Re: Greenway Exit 5 cell tower buffer — SPEX 2009-0030

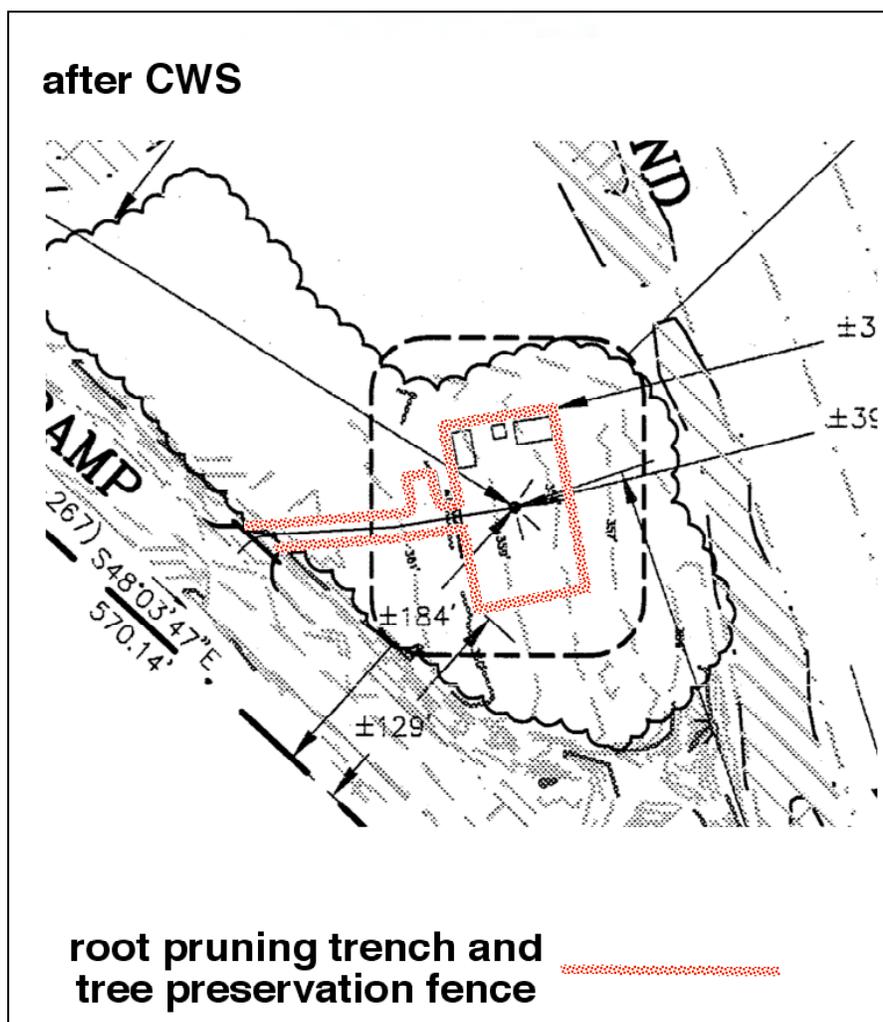
To maintain this buffer, I would suggest that the limits of clearing and grading for the facility footprint be rootpruned, and tree preservation fence be installed to limit activity to the area being cleared — see the drawing to the right. This will maximize survival of the trees outside the facility.
